SUBJECT: JOSEPH M. FARLEY NUCLEAR PLANT, UNITS 1 AND 2 – STAFF  
ASSESSMENT OF RESPONSE TO 10 CFR 50.54(f) INFORMATION  
REQUEST – FLOOD-CAUSING MECHANISM REEVALUATION  
(CAC NOS. MF7039 AND MF7040)

STAFF ASSESSMENT BY THE OFFICE OF NUCLEAR REACTOR REGULATION  
RELATED TO FLOODING HAZARD REEVALUATION REPORT  
NEAR-TERM TASK FORCE RECOMMENDATION 2.1  
JOSEPH M. FARLEY NUCLEAR PLANT, UNITS 1 AND 2  
DOCKET NOS. 50-348 AND 50-364

Figure 3.1-2 Topographic Map of Power Block Area (Elevations in NAVD88) (Derived from SNC, 2015b).

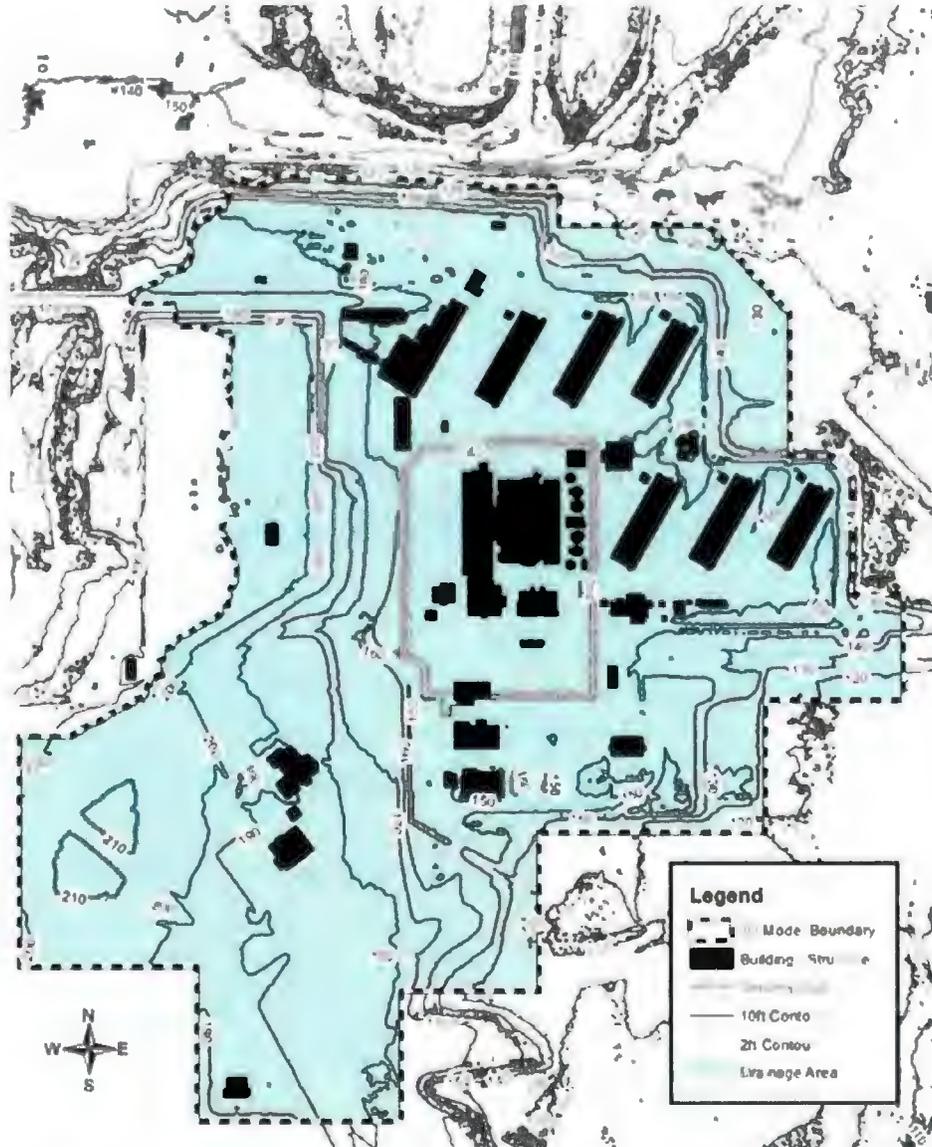
The power block area shown in Figure 3.1-2 is at elevation 154.5 ft (47.09 m). The service water intake structure, which is located south of the power block area, is at elevation 195.0 ft (59.44 m).
